RECORD PLANS

PROPOSED IMPROVEMENT
TOWN OF JAMAICA
COUNTY OF WINDHAM
VT. ROUTE 100
MINOR ARTERIAL

WORK TO BE PERFORMED UNDER THIS PROJECT CONSISTS OF THE REPLACEMENT OF EXISTING BRIDGE #80, ON VT ROUTE 100, INCLUDING ALL NECESSARY ROADWAY APPROACH WORK.

2 - FLOOR BEAMS - 122FB

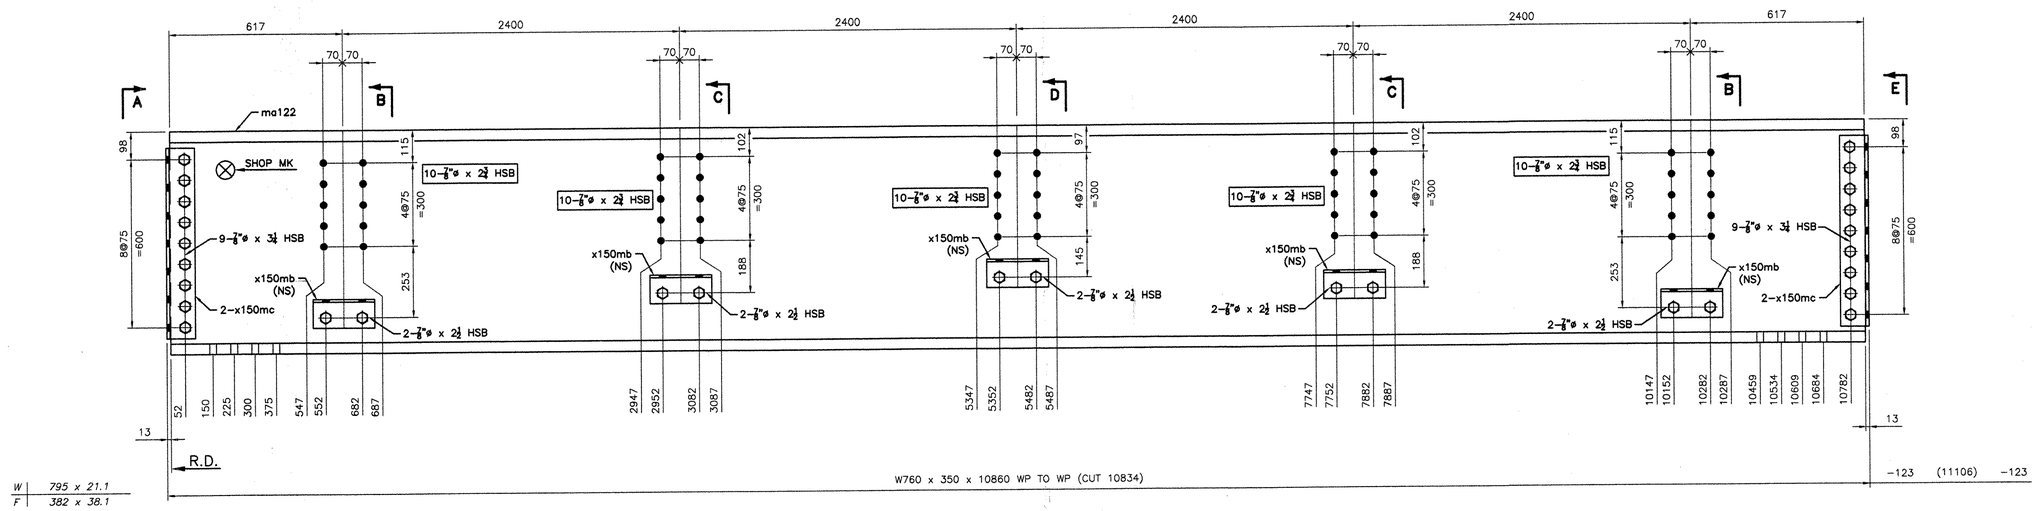
We still need revised sheets for sheets 122, 123, and 124, to reflect that the holes in the floor beam for the floorbeam to truss connection will be 1 1/16" and the bolts 1" diameter.

2 –TOP STRUT ASSEMBLY – 130TS

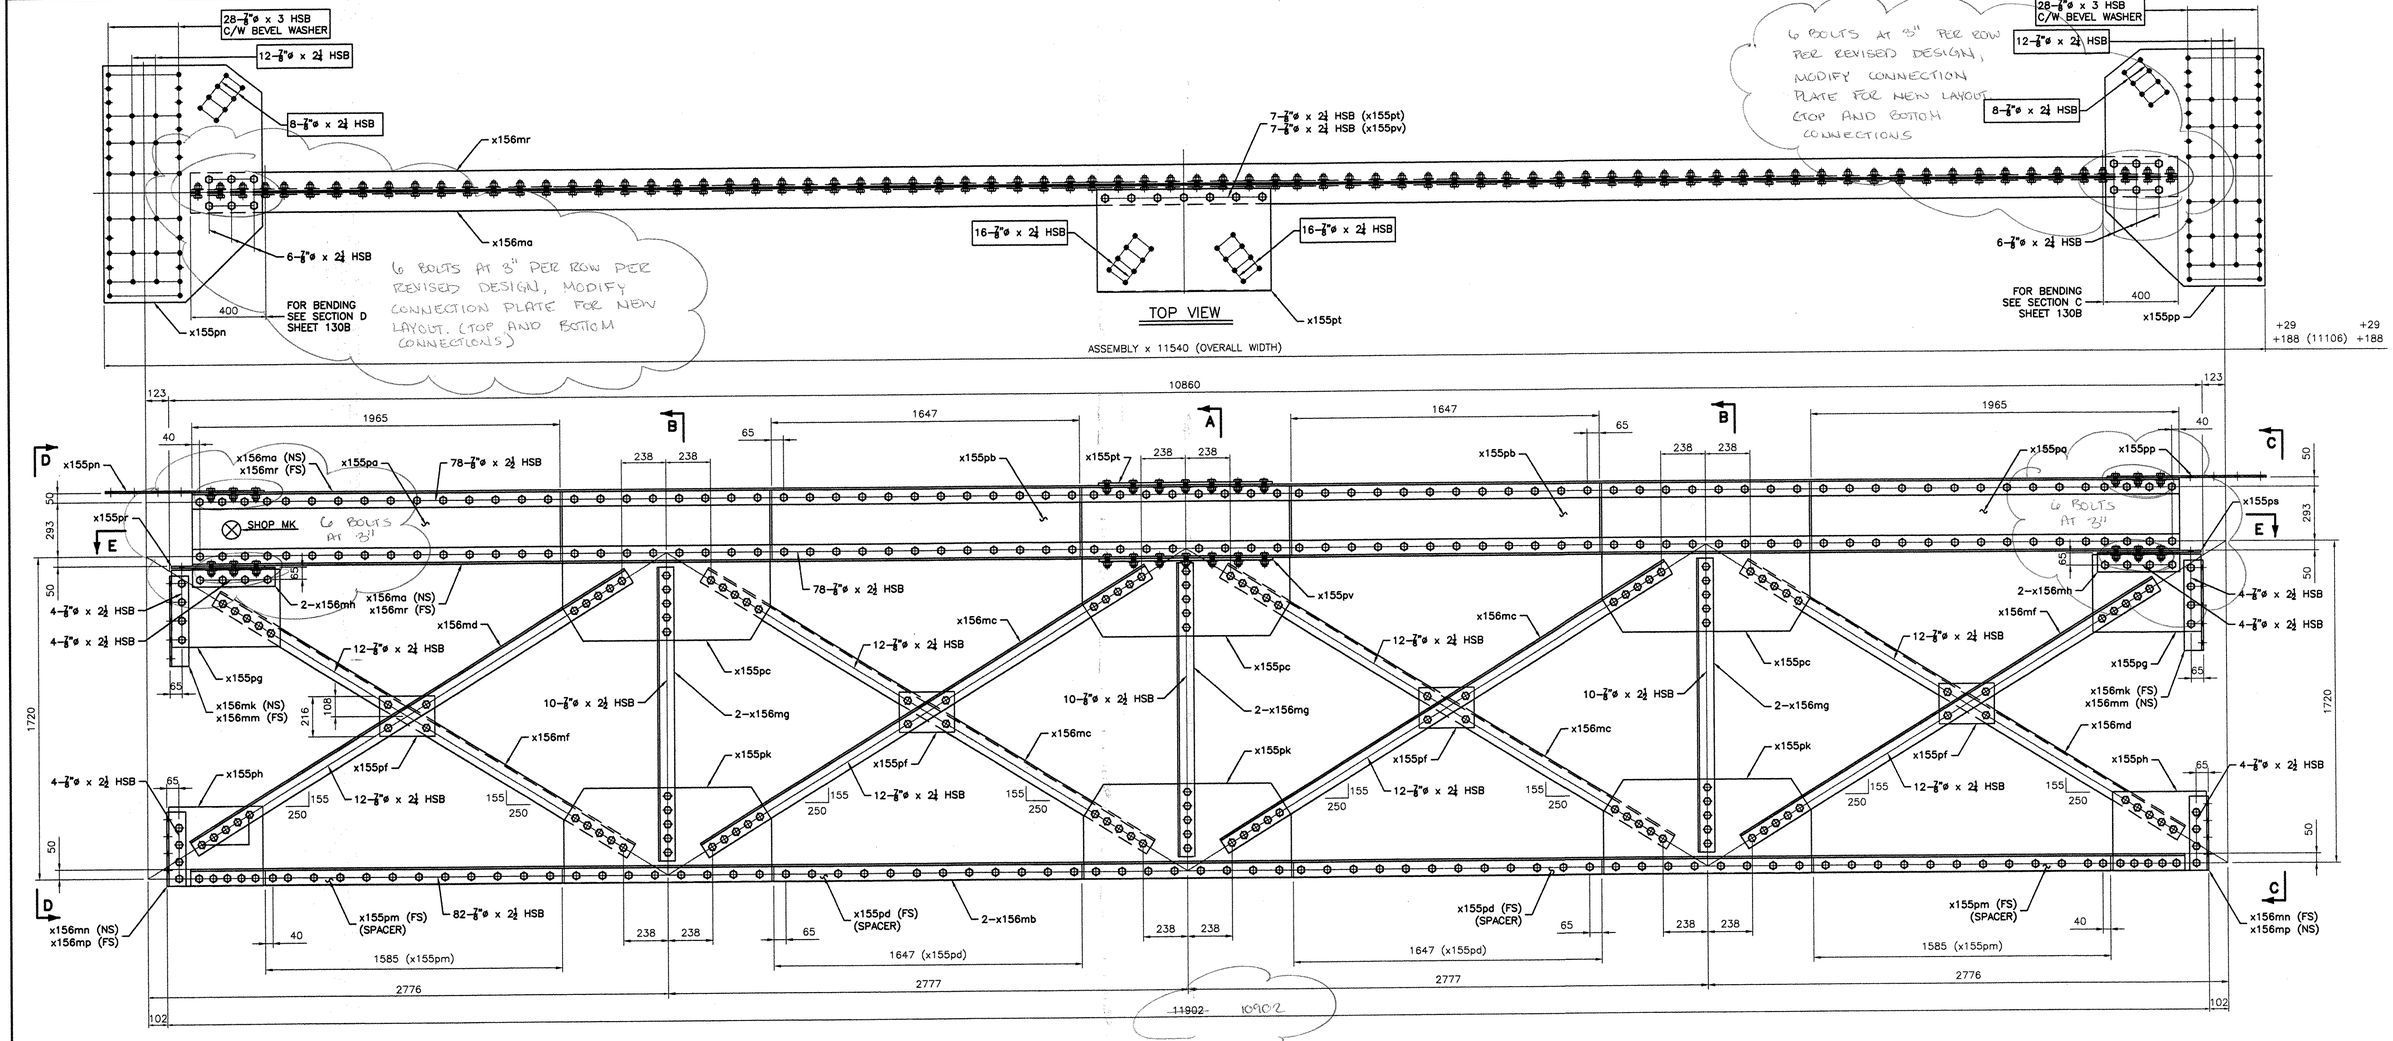
A review of the truss shop drawing submittal has been completed. The drawings are stamped "Provide as Corrected"; however, the details of the top strut connection to the top chord (sheets 130B and 131B) must be resubmitted to eliminate the bent angles as currently shown.
